SUBJECT: CATAWBA NUCLEAR STATION, UNITS 1 AND 2 RE: ISSUANCE OF AMENDMENTS (TAC NOS. MA2359 AND MA2361)

The amendments revise various sections of the Technical Specifications (Appendix A of the Catawba operating licenses) to permit use of Westinghouse's Robust Fuel Assemblies for future core reloads. We will publish a Notice of Issuance in the Commission's biweekly *Federal Register* notice.

AMENDMENT TO FACILITY OPERATING LICENSE

Amendment No. 180
License No. NPF-35

Figure 2.1.1-1
Reactor Core Safety Limits
Four Loops in Operation

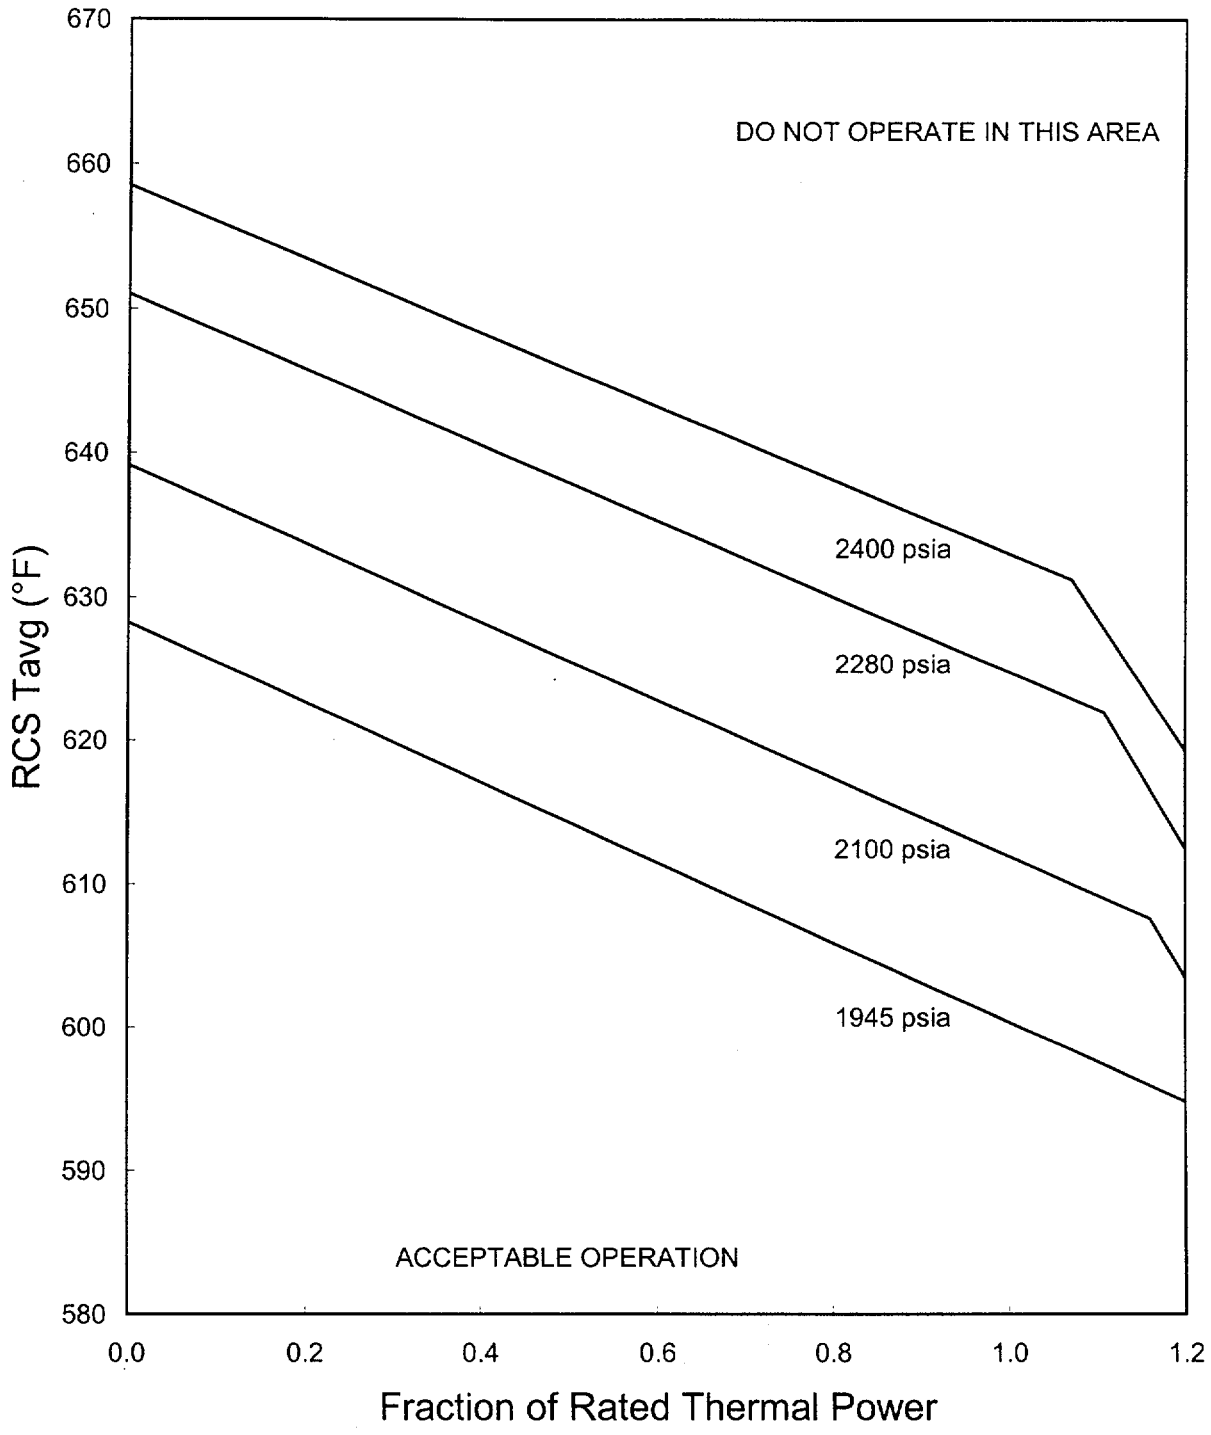
The licensee proposed to modify Figure 2.1.1-1, "Reactor Core Safety Limits - Four Loops in Operation," by (1) deleting the 2455 psia safety limit line, which is the current upper bound pressure allowed for power operation; (2) combining separate Unit 1 and Unit 2 figures into only one figure; and (3) revising the other safety limit lines (see following paragraph). The resulting Figure 2.1.1-1 was submitted by a letter, M. Tuckman to NRC, dated June 24, 1999 (Ref. 39).

The 2455 psia bounding pressure is based on the pressure range of the CHF correlation used in DNBR analyses of the Mark-BW fuel. Since the upper range of applicability of the WRB-2M CHF correlation for the RFA design is 2425 psia, the 2455 psia safety limit line is deleted, and the remaining safety limit lines with 2400 psia as the upper bound safety limit line are within the range of the CHF correlations for the Mark-BW and RFA fuel designs. As described in its response to a staff's question (No. 12, Ref. 14), the licensee has performed an evaluation to ensure the remaining safety limit lines of Figure 2.1.1-1, which were based on the CHF correlation for the Mark-BW fuel design and the hot leg boiling limit, bound the safety limit for the DNBR limit of the WRB-2M correlation for the RFA design. Both the full RFA core and the transition RFA/Mark-BW cores were evaluated to ensure that the established limits were conservative. The DNBR values were greater than the design DNBR limit for all the cases in both evaluation. Therefore, the safety limit lines in Figure 2.1.1-1, with the deletion of the 2455 psia safety limit line, are acceptable.
